REMEDICATION SYSTEM EVALUATION (RSE)

CENTRAL CITY/CLEAR CREEK SUPERFUND SITE
ARGO TUNNEL WATER TREATMENT PLANT
IDAHO SPRINGS, COLORADO

Report of the Remediation System Evaluation
Site Visit Conducted May 16, 2007

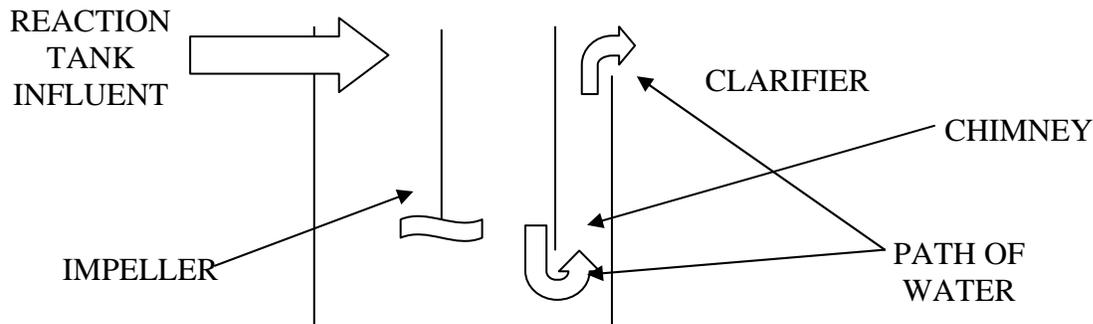
With the current reaction tank design, water must flow up past the impeller in the center of the tank, over a baffle into the outer portion of the tank, down to the bottom of the tank, and then up the entire height of the tank over a baffle into the clarifier (see figure below).

This is a relatively tortuous path for the solids-laden water to travel. Typically, a baffle is provided to prevent the turbulence associated with mixing from affecting the clarifier; however, this design appears to include additional separation. Solids settling within the chimney might be greatly reduced if the inner walls of the reaction tank were removed and the baffle between the tank and the chimney was raised/shortened so that the mixing of the impeller would prevent solids from settling in the tank and the upward path to the clarifier is shortened. The influent location and impeller and mixer design may need to be modified to provide adequate mixing in this larger tank volume. A figure of the potential revised design is shown below.

If this approach is not possible, the site team might consider adding additional mixing or turbulence to the existing chimney area to prevent settling.
